DESCRIPTION: Ltr notarized 11-24-75 farn
addl info on control rod drop transient
& minimum departure from nucleate boiling
ratio calculations: & atrans the following:

PLANT NAME: H.B. Robinson Unit 2

RE: H. B. ROBINSON UNIT NO. 2
DOCKET NO. 50-261
FACILITY OPERATING LICENSE NO. DPR-23

ENCLOSURE BDROPPED ROD TRANSIENT ASSUMING
NO TURBINE RUNBACK AND NO ROD BLOCK

Figure 1

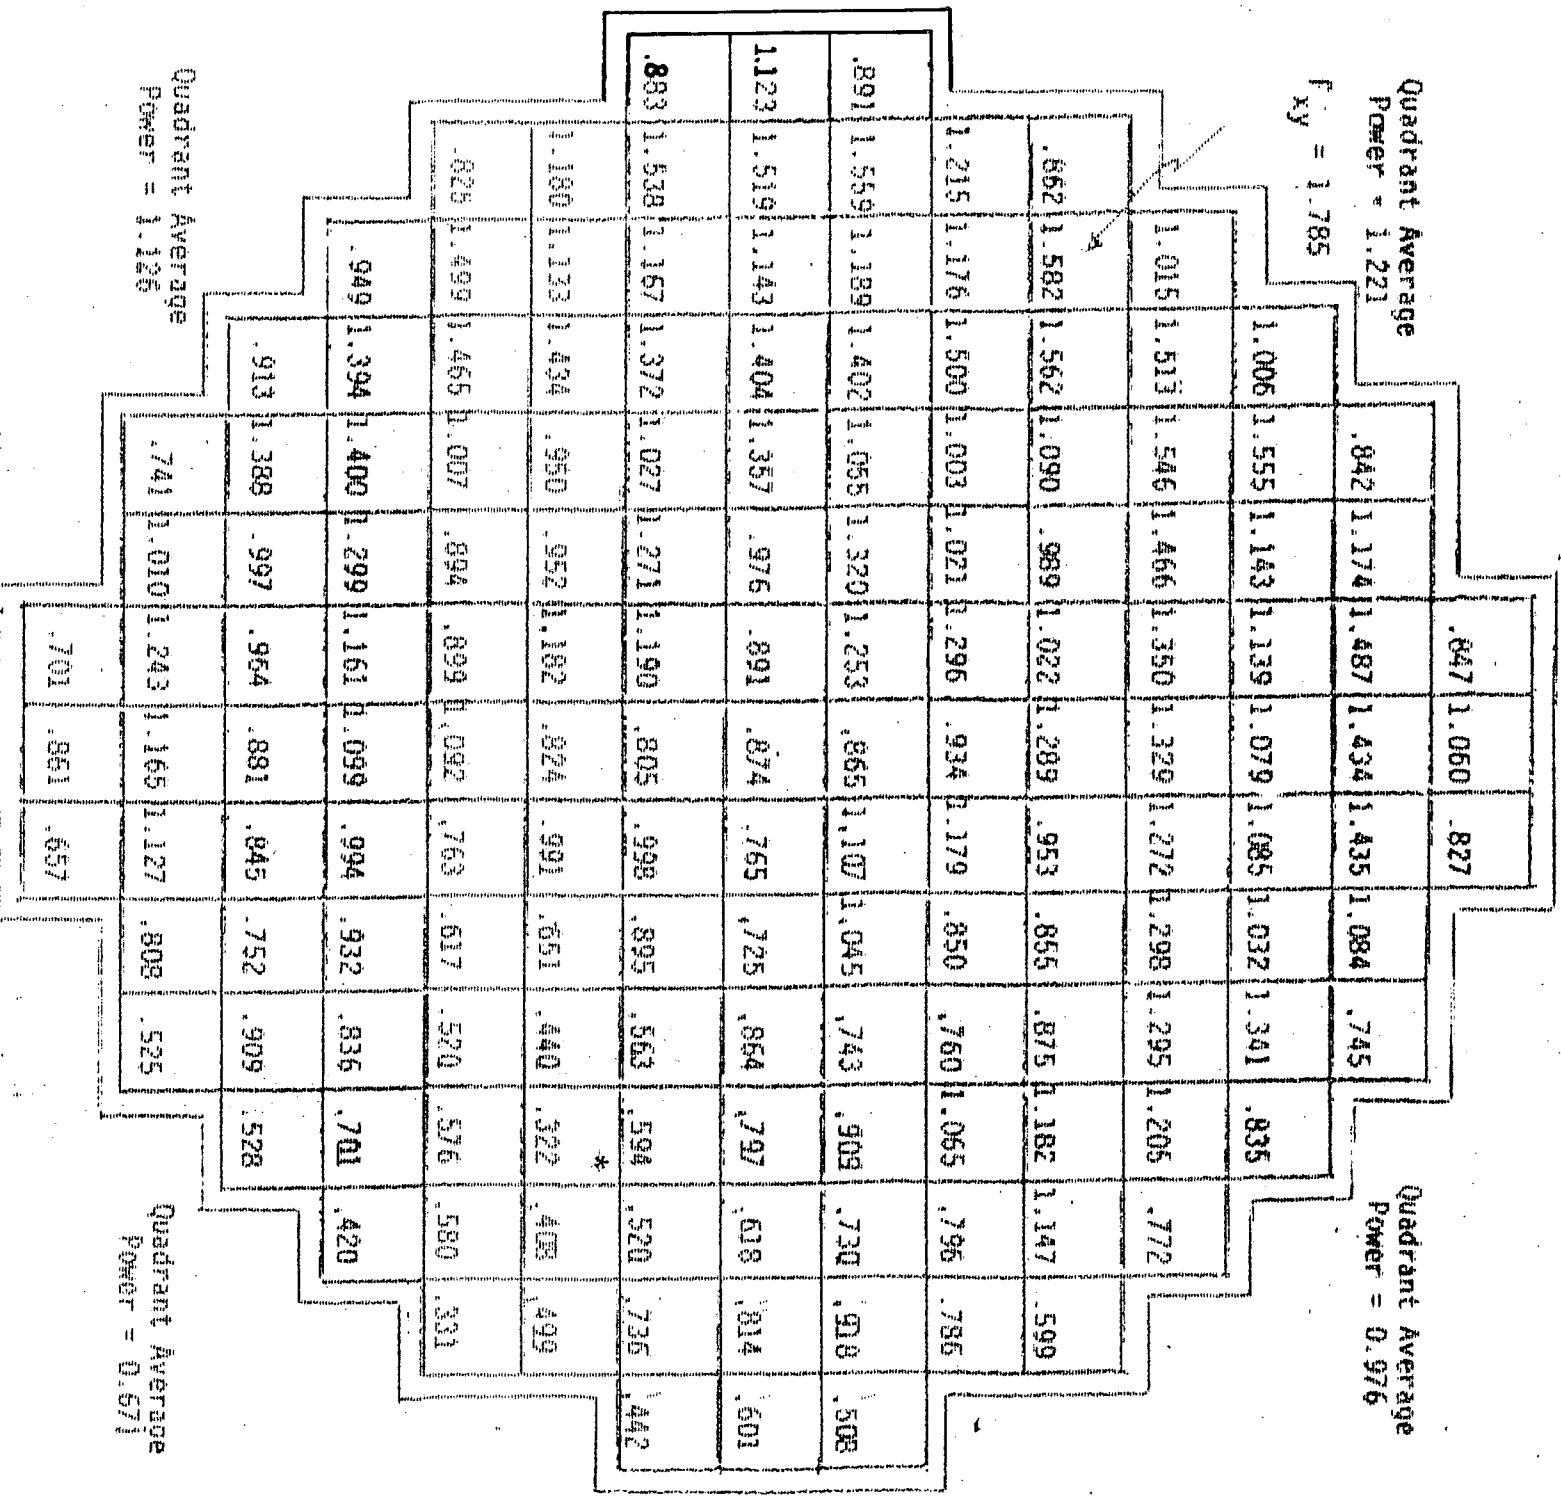
The radial power distribution with the "dropped rod" inserted is shown on Figure 1. On a quadrant-to-quadrant basis, the calculation indicates a radial tilt of about 22% for the particular dropped rod analyzed. The calculated worth of the dropped rod was $1.13 \times 10^{-3} \Delta p$.
